MINUTE NO. 196

MODIFICATION OF THE ORIGINAL PLAN FOR THE
LOWER RIO GRANDE INTERNATIONAL FLOOD
CONTROL PROJECT.

JOINT REPORT OF THE PRINCIPAL ENGINEERS
RECOMMENDING MODIFICATION OF THE ORIGINAL PLAN FOR THE
LOWER RIO GRANDE INTERNATIONAL FLOOD CONTROL PROJECT

INTERNATIONAL BOUNDARY & WATER COMMISSION
UNITED STATES & MEXICO
LOWER RIO GRANDE FLOOD CONTROL PROJECT
ANZALDUAS DIVERSION DAM
PLAN AND SECTIONS

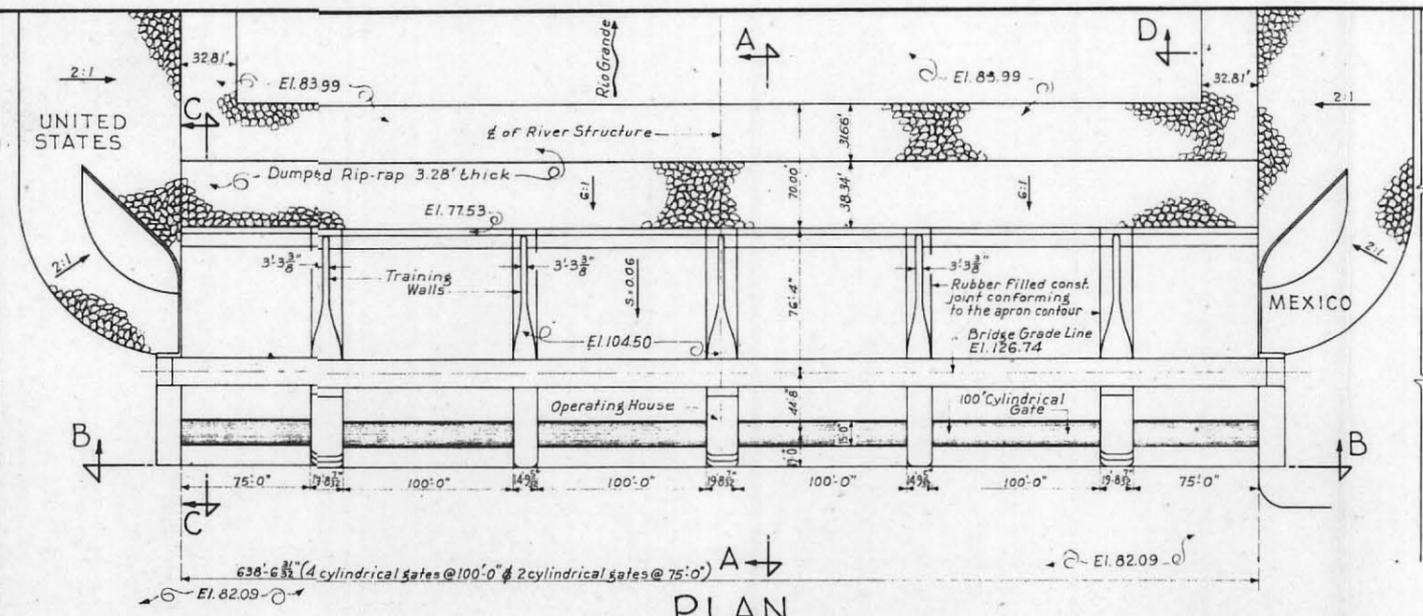
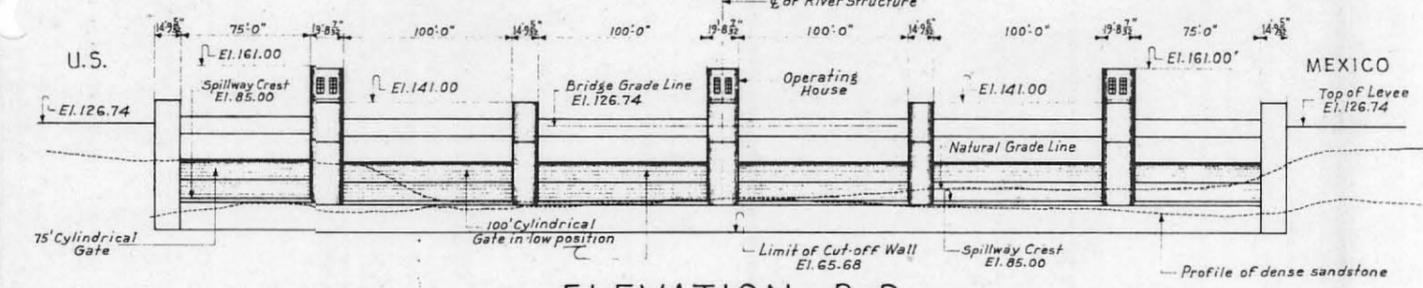
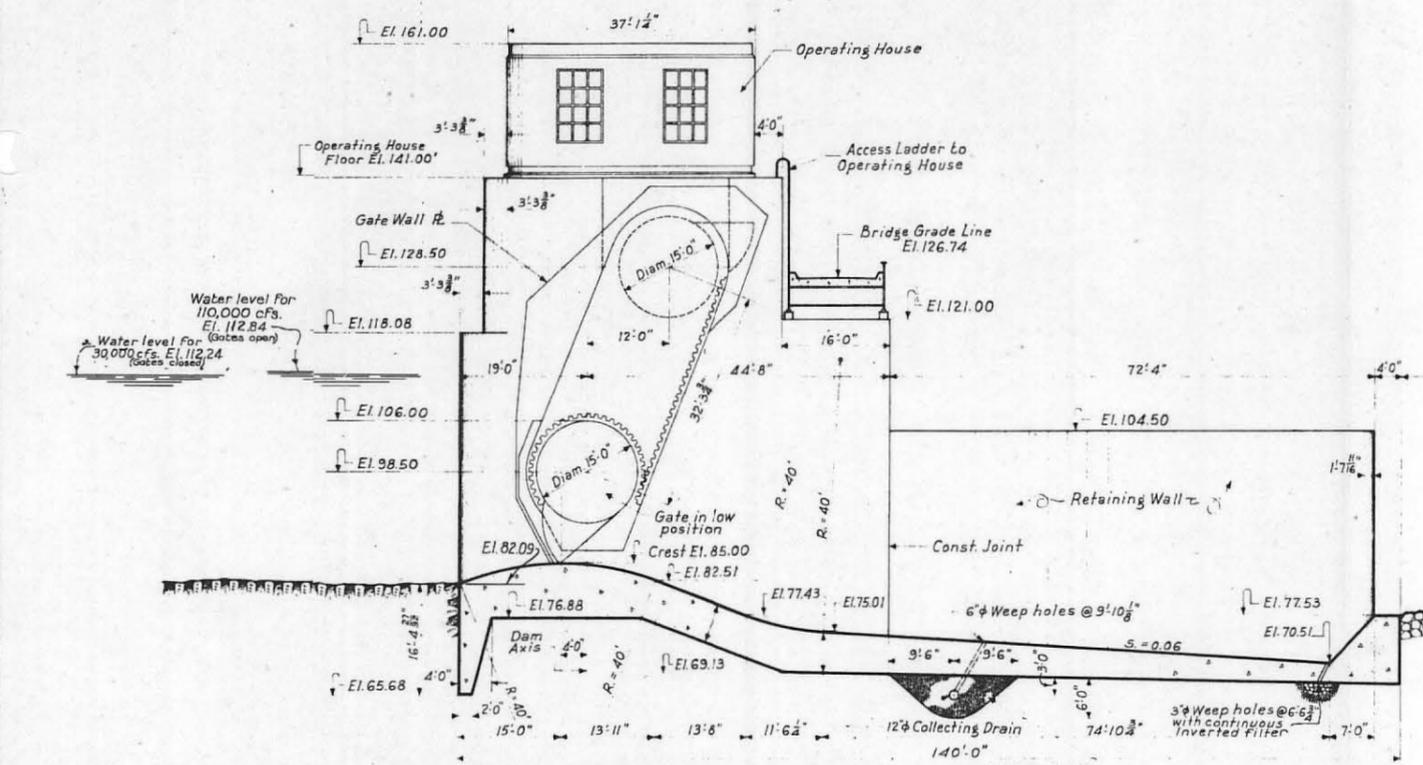
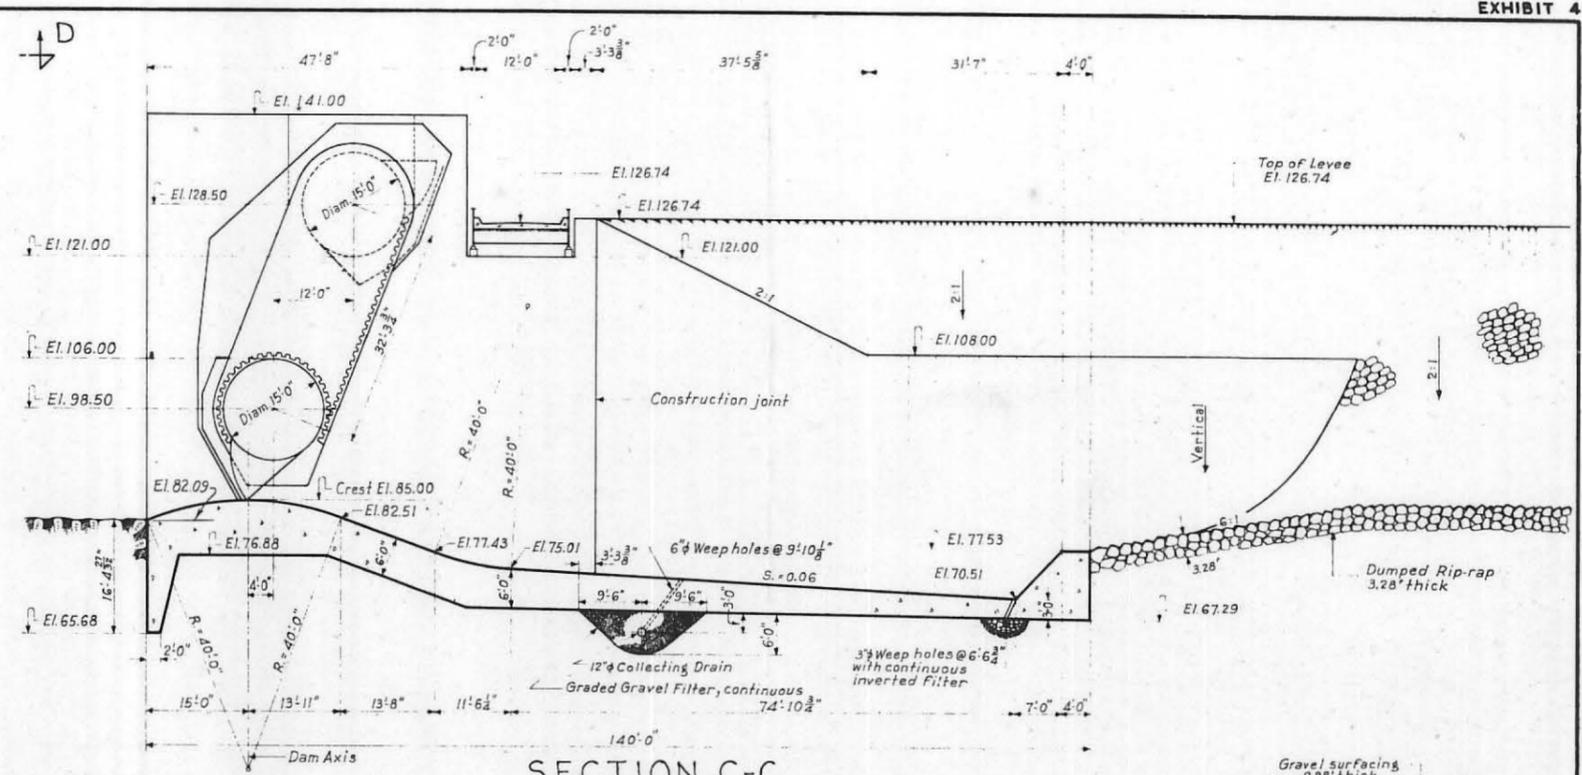
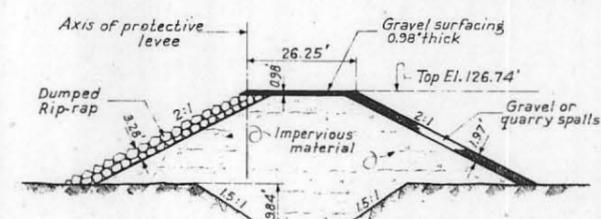
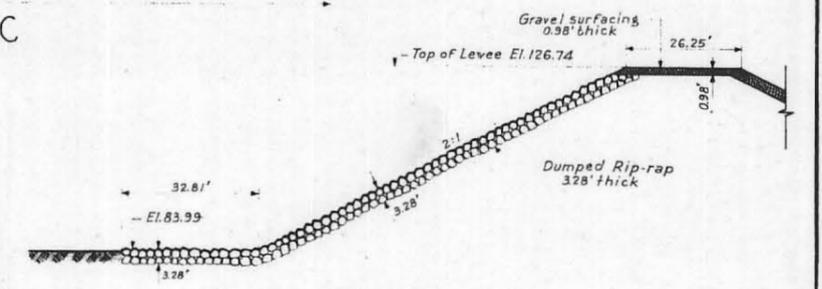
A preliminary drawing, "Anzaldúas Diversion Dam - Plan and Sections", is shown in Exhibit No. 4. The dam is a concrete structure founded on sandstone with the gate sill located 1 foot above the present river bottom, and
with

with training dikes on both ends of the structure. The structure will be 640 feet between abutments and 140 feet in length along the river. Control is furnished by four roller gates, each 15 feet in diameter, with a 6-foot lip, and 100 feet long. The crest of the roller gates in a closed position will be at elevation 106.00. The total travel of the roller gates from closed to fully open position is 32.15 feet, and in fully open position the gates will clear the maximum high water surface by 5 feet. Immediately adjacent to the main gate on each side is a roller sluice gate 75 feet in length. A service bridge with 12-foot roadway is provided along the downstream part of the piers. Hoist houses are provided on the piers on which the machinery for raising the roller gates will be installed. The stilling basin below the gates is designed so that the hydraulic jump will be contained within the basin even under the most adverse condition which is assumed to be that with one gate partially open and with headwater at the top of the other three gates. Below the stilling basin 70 feet of riprap paving will be installed in the river channel section. The plan of the dam is such that either country may readily install irrigation diversion facilities above the structure. Further design studies may show that revisions should be made in the plans for the gates and in the shape of the lining below the gates.
